Service Update

N222362410 Main Body Wire Harness Contact Damage

Release Date: May 2022

Subject: N222362410 - Service Update
Main Body Wire Harness Contacts Intermediate Steering Shaft Joint

6043726

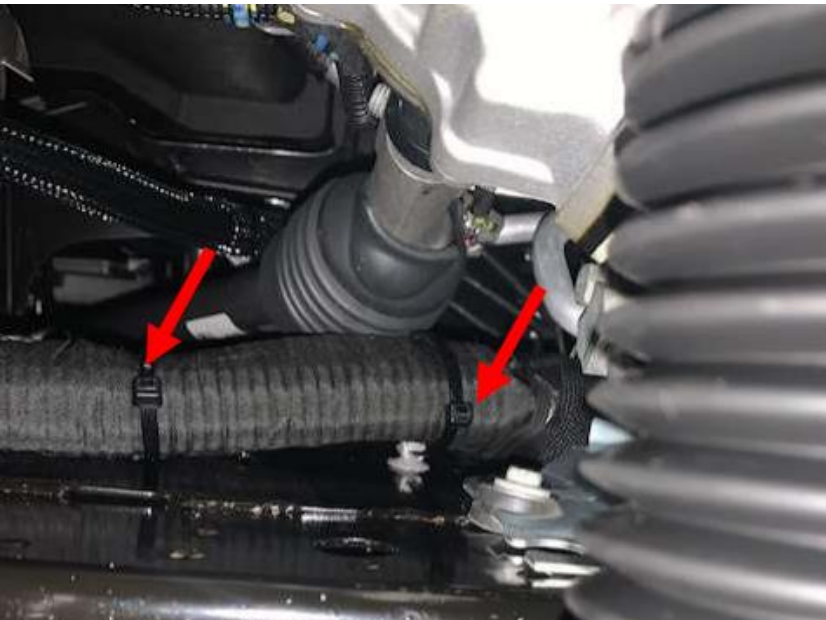
4. Locate the wire harness running along the driver's side frame rail beneath and behind the steering gear intermediate shaft as shown.
5. Inspect the wire harness for any damage.
 - If no damage is found, proceed to the next step.
 - If any damage is found, repair the wire harness. Refer to *Wire to Wire Repair* in SI.

6051378

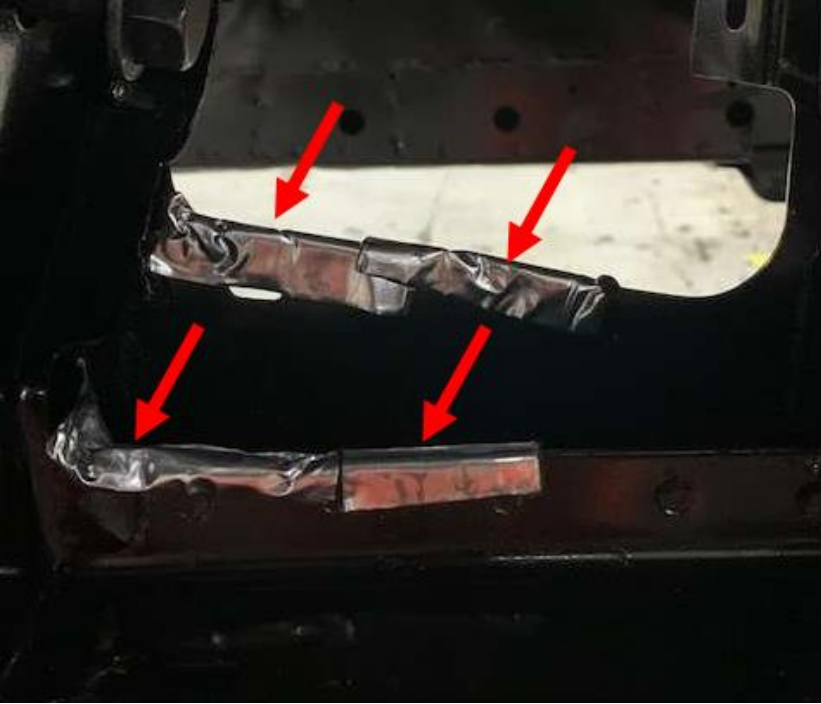
6. Rotate the zip tie strap ends so the tie strap ends point either up or down as shown. They should not point toward the I shaft boot.

6051425

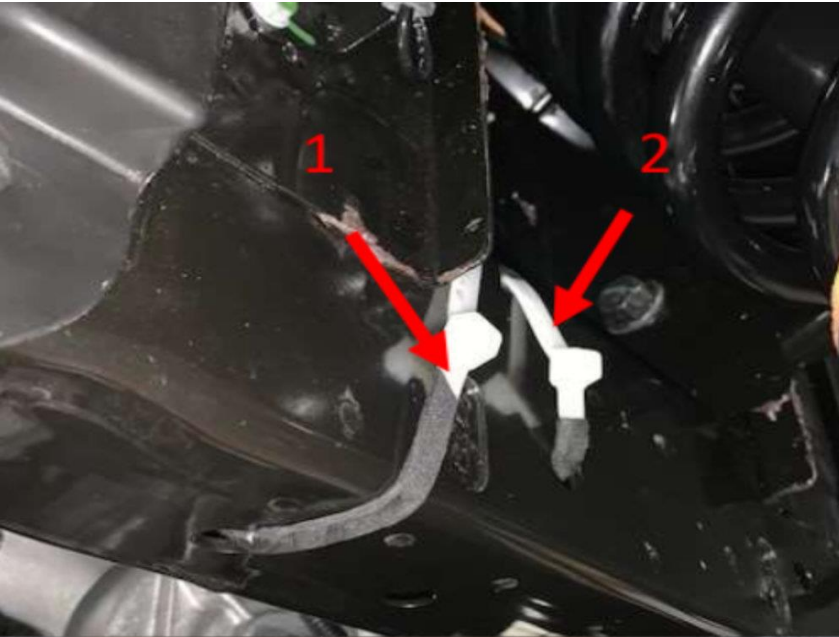
7. Install four butyl patches in locations shown.

6051422

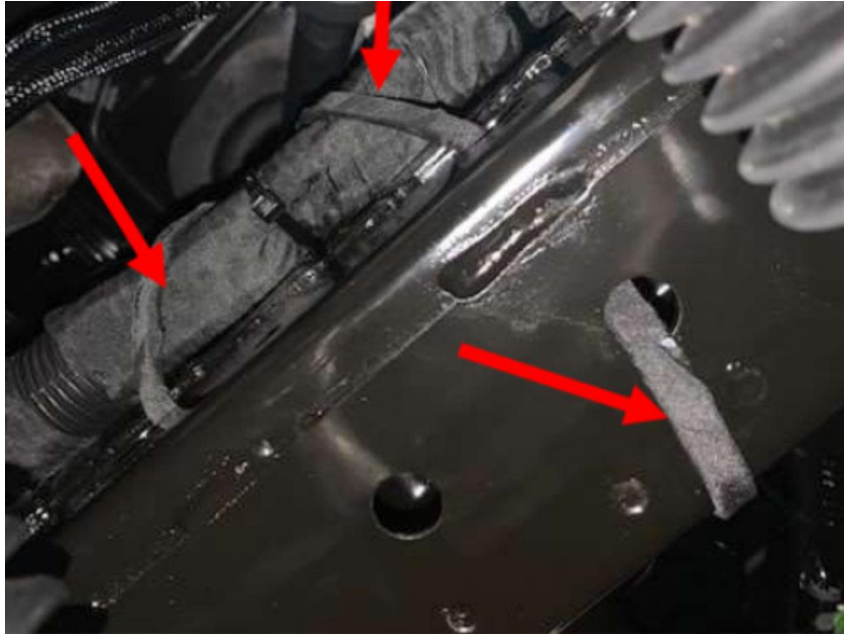
8. Install the zip tie (1) through the bottom hole in the frame and feed it through the adjacent inner side rail hole as shown. Wrap the zip tie around the main body wire harness and tighten by hand, then use pliers to snug the zip tie down all the way.

9. Install the zip tie (2) through the holes that go directly through the center of the frame rail as shown. Wrap the zip tie around the main body wire harness and tighten by hand, then use pliers to snug the zip tie down all the way.
